SUBJECT: CORPORATE AND STATION STAFF ORGANIZATIONAL STRUCTURE (TAC NO. 66115)

RE: PEACH BOTTOM ATOMIC POWER STATION, UNIT NOS. 2 AND 3

These amendments would modify Section 6 of the facility Technical Specifications to reflect (I) a new corporate and (II) a new plant staff organizational structure, (III) a revised composition of the Plant Operations Review Committee and (IV) several administrative changes.

I. Offsite Management and Support Organization, Figure 6.2-1

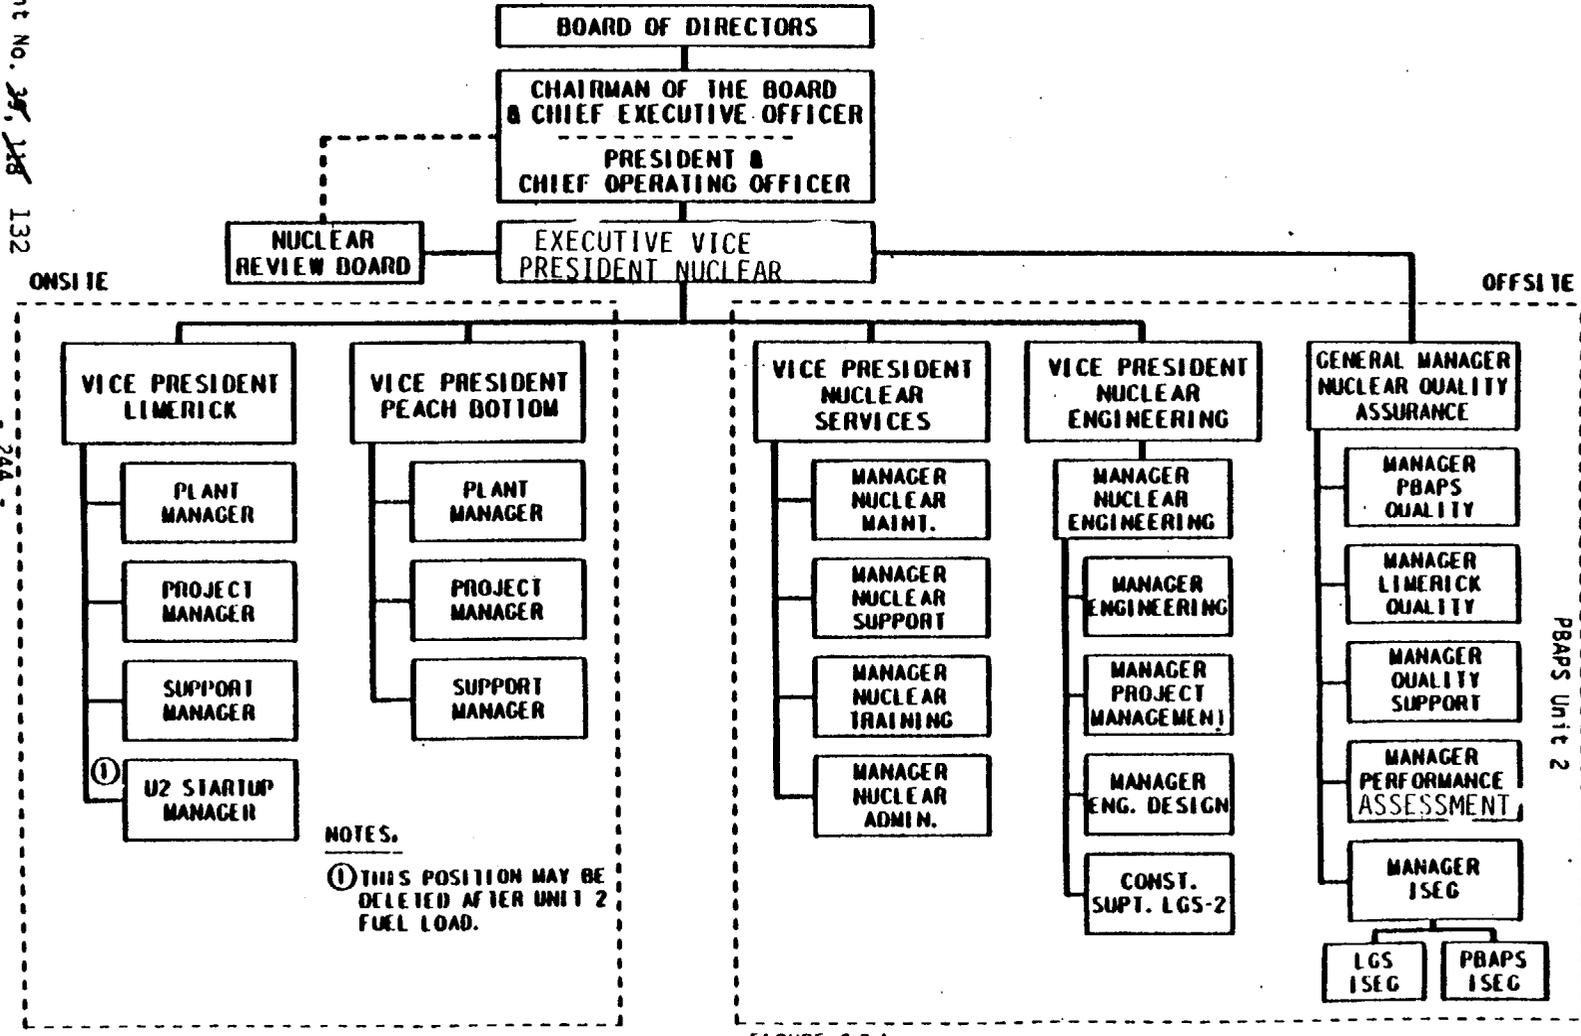
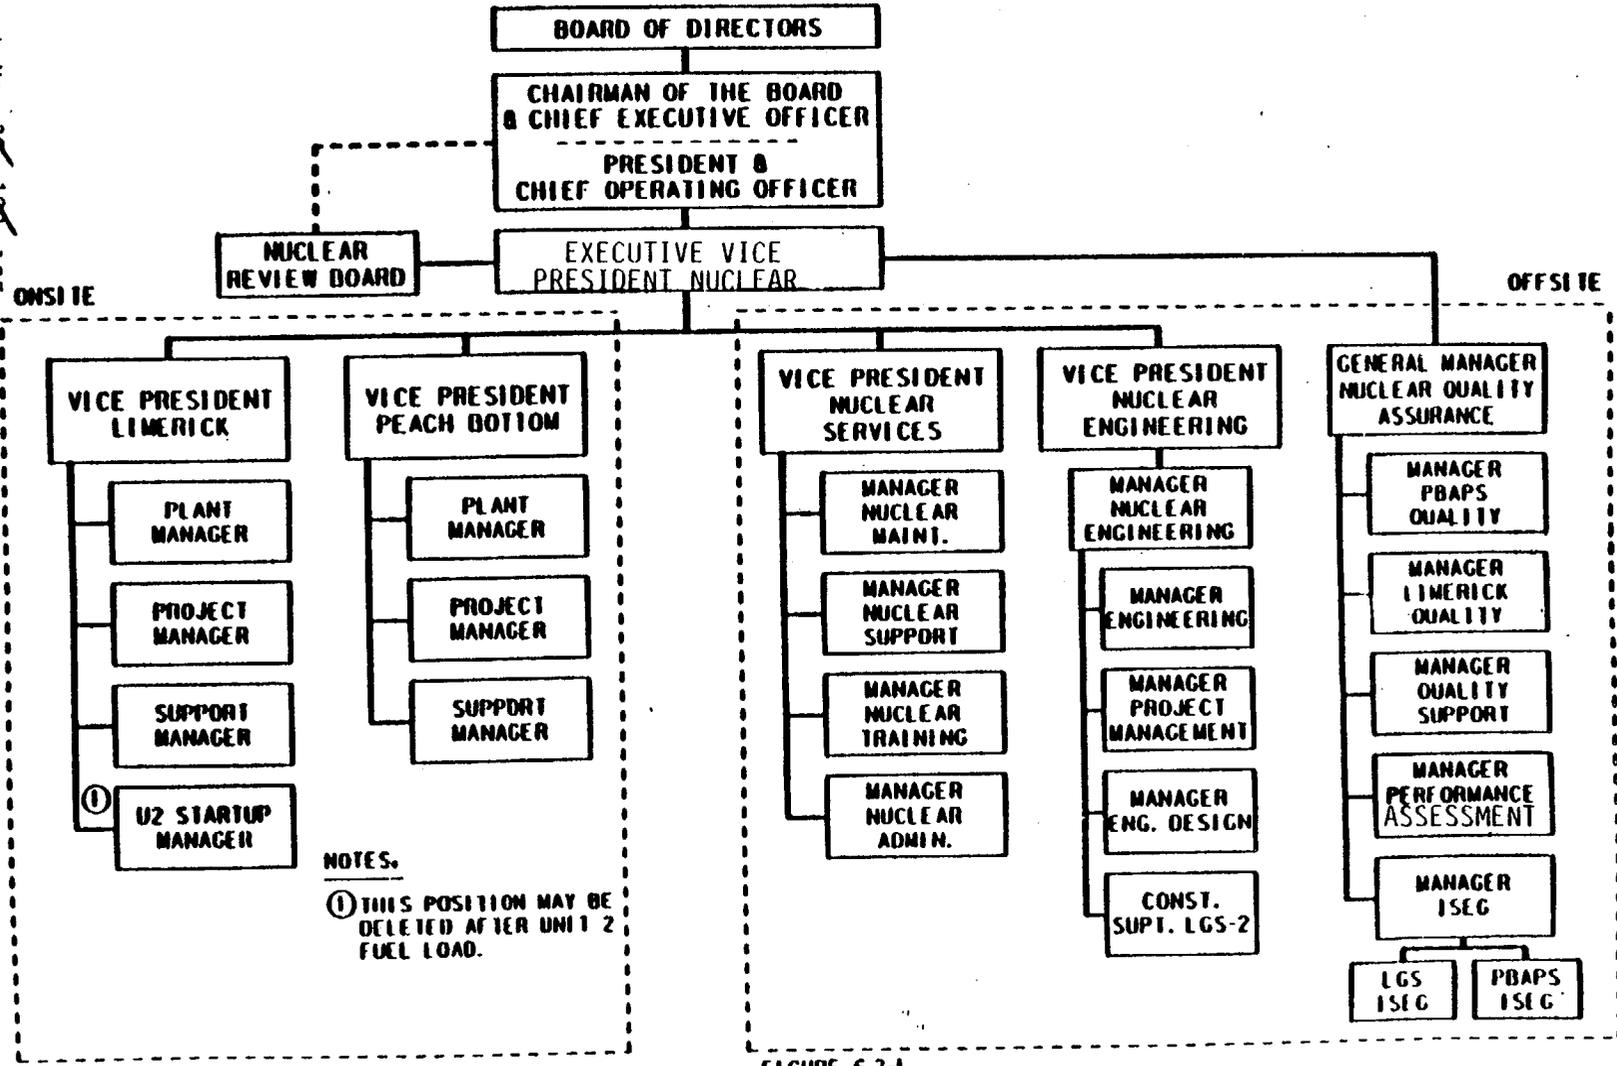
President-Nuclear Power, Nuclear Production Manager, Superintendent-Nuclear Generation Division, Superintendent-Nuclear Services, and Manager-Nuclear Plant have been abolished and the functions under these positions have been reassigned within the new organization under the Executive Vice President-Nuclear. Revision I of the Plan for Restart included a change in the title of the senior nuclear executive to Executive Vice President-Nuclear. The new organization is shown in revised Technical Specification (TS) Figure 6.2-1. Reporting to the Executive Vice President-Nuclear are the Senior Vice President-Nuclear, Vice President-Nuclear Services, Vice President-Nuclear Engineering, General Manager-Nuclear Quality Assurance, Vice President-Limerick and Vice President-Peach Bottom. In addition, the Nuclear Review Board (NRB) reports directly to the Executive Vice President-Nuclear.

The new office of Vice President-Nuclear Services has responsibility for nuclear service activities that support the station. Reporting to the Vice President-Nuclear Services are the Manager-Nuclear Support, Manager-Nuclear Maintenance, Manager-Nuclear Training, and Manager-Nuclear Administration. The Manager-Nuclear Support is responsible for licensing, fuel management, radiation protection, radioactive waste management, nuclear plant chemistry, emergency preparedness, nuclear plant security and the Operating Experience Assessment Program.

We have reviewed the requested changes and found them acceptable as they meet the acceptance criteria of the appropriate parts of Section 13.1.1 of NUREG-0800, the Standard Review Plan.

II. Onsite Management Organization, TS Figure 6.2-2

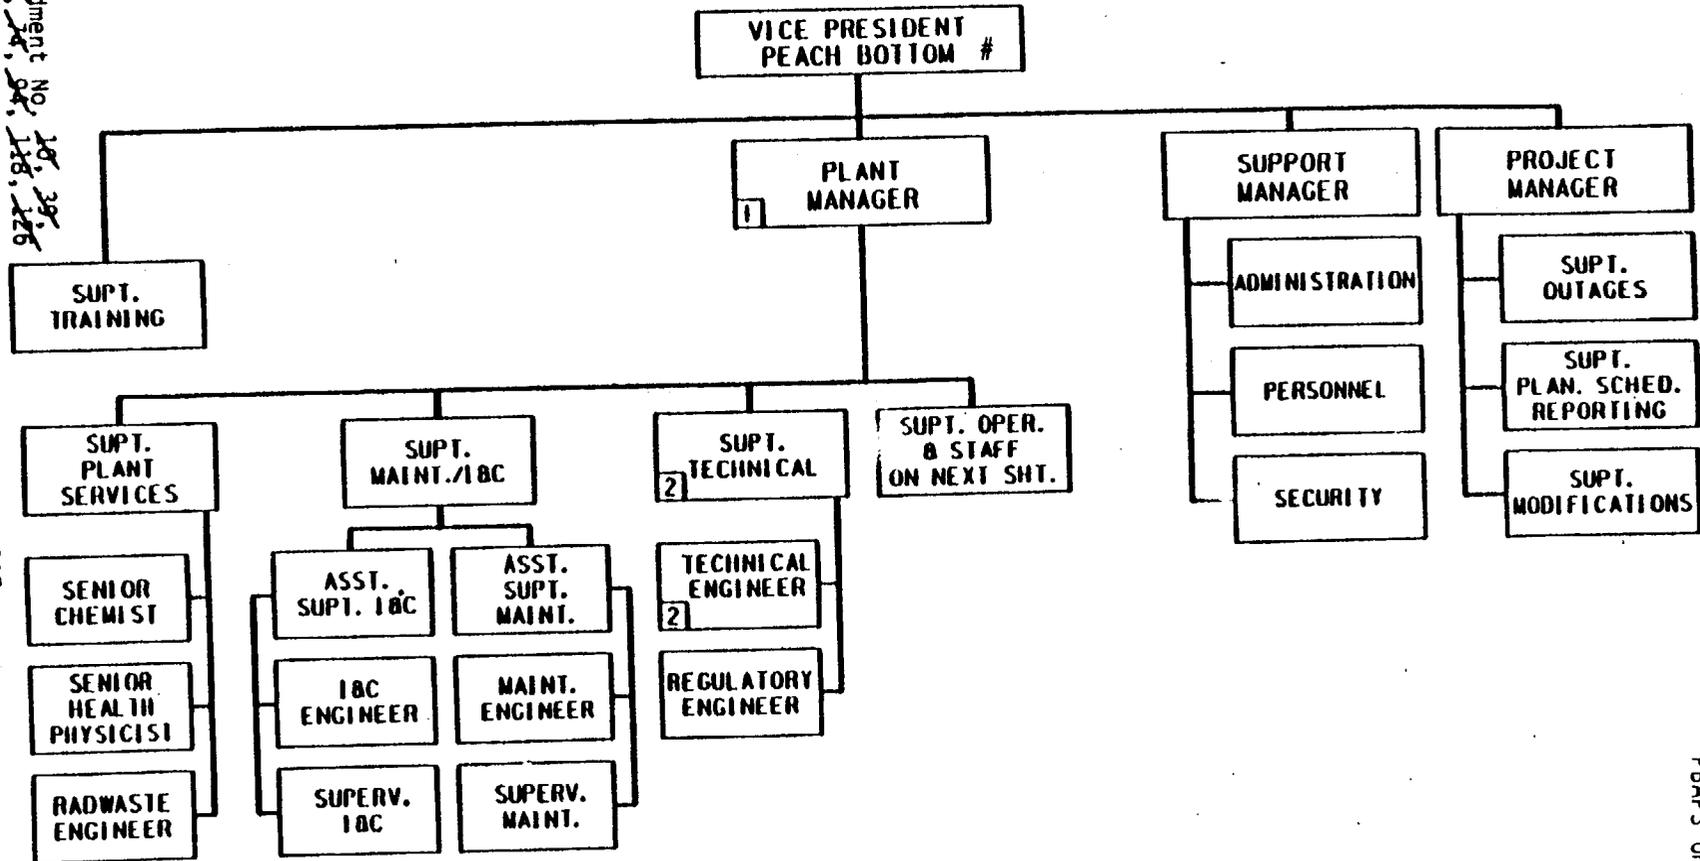
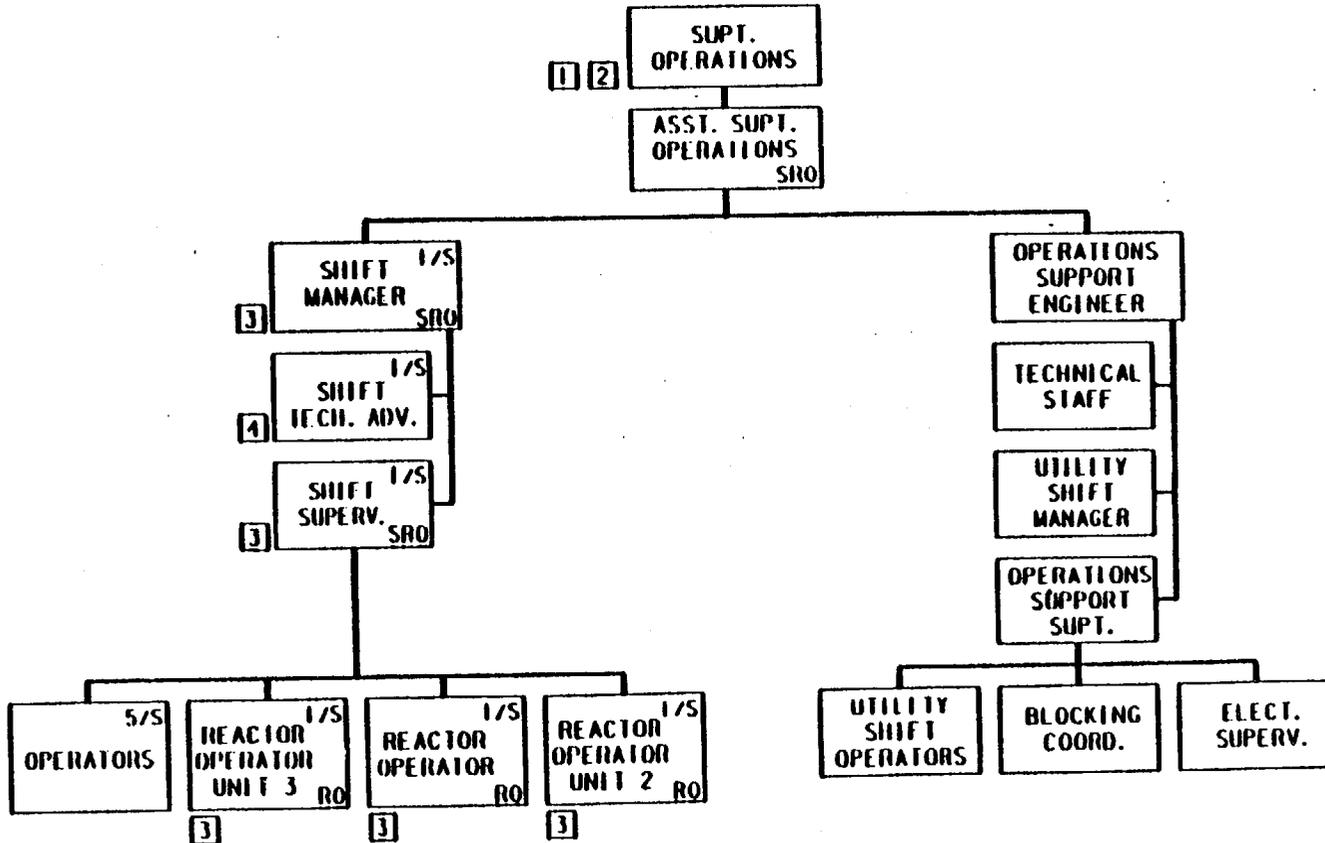
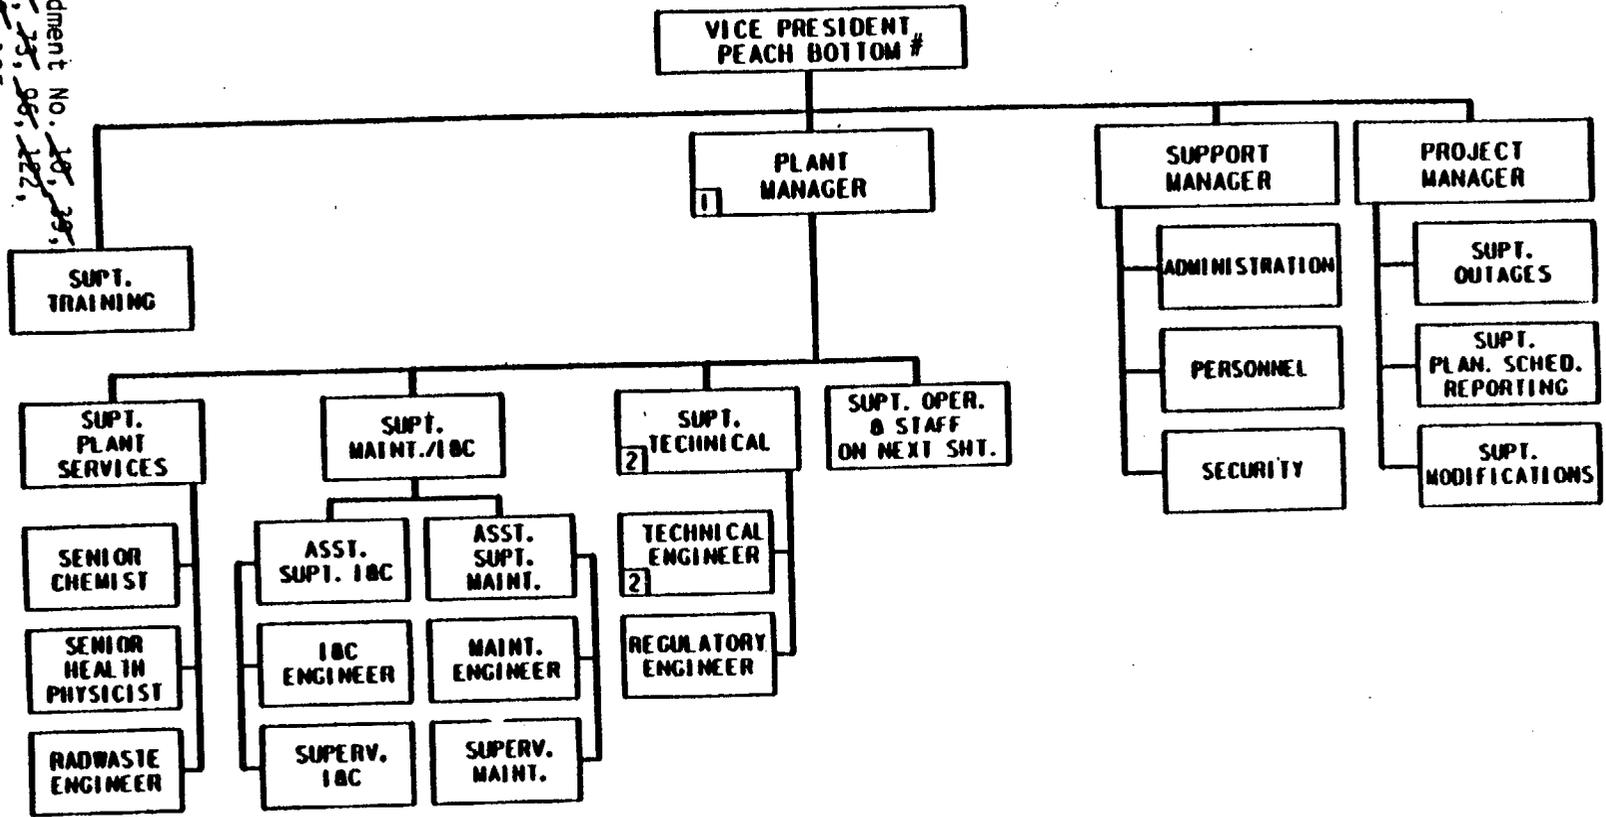
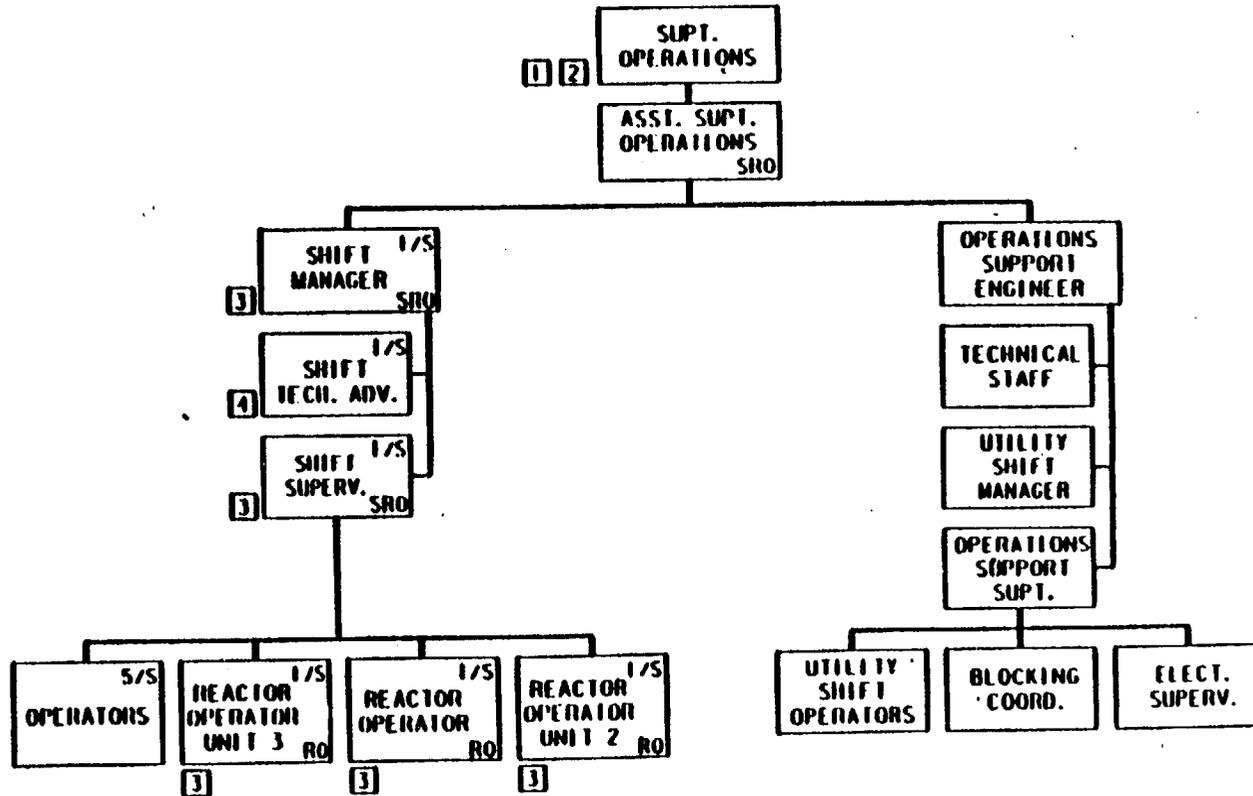
PECo has established a new office of Vice President-Peach Bottom Atomic Power Station which will have overall control for the conduct of activities of all organizations at the Peach Bottom site. The Vice President-Peach Bottom Atomic Power Station will be located at the Peach Bottom site. PECO has reassigned current functions and added new functions under a Plant Manager, Support Manager, Project Manager and Superintendent-Training, who all report directly to the Vice President-Peach Bottom. The licensee also proposed to delete the designation of the Nuclear Generation Division (NGD) Superintendent as being responsible for the overall fire protection program. This designation was made in amendment number 39 and the licensee does not provide sufficient specificity in its application regarding how this responsibility will otherwise be met. Therefore this request is denied as stated in the Federal Register (52 FR 48593-48597) on December 23, 1987. Designation of this responsibility will remain with the VP-PBAPS, which is the level of responsibility approximately equal to that of the NGD Superintendent in this regard.

The Plant Manager will be responsible for operating the plant safely, reliably, and efficiently in accordance with all applicable requirements. Reporting to the Plant Manager are the Superintendent Plant Services, Superintendent-Maintenance/Instrumentation and Controls, Superintendent Technical, and Superintendent Operations.

The Superintendent-Operations will be responsible for management oversight of shift operations. Reporting directly to the Superintendent-Operations is an Assistant Superintendent-Operations. Reporting to the Assistant Superintendent-Operations are the Shift Managers and an Operations Support Engineer. The Shift Managers will manage the operations of the plant on their assigned shifts. The Operations Support Engineer provides support to the operating shifts. Reporting to the Operations Support Engineer will be a Technical Staff, Utility Shift Manager and Operations Support Superintendent. The licensee did not propose any change in the interim relief granted by amendments 126 and 129 regarding the holding of an SRO license by either the Plant Manager or the Superintendent-Operations. Therefore, the relief provided by those amendments continues in effect and is shown on Figure 6.2-2.

The Assistant Superintendent-Operations will hold a Senior Reactor Operator License and the Superintendent-Operations or the Plant Manager will hold a Senior Reactor Operator License.
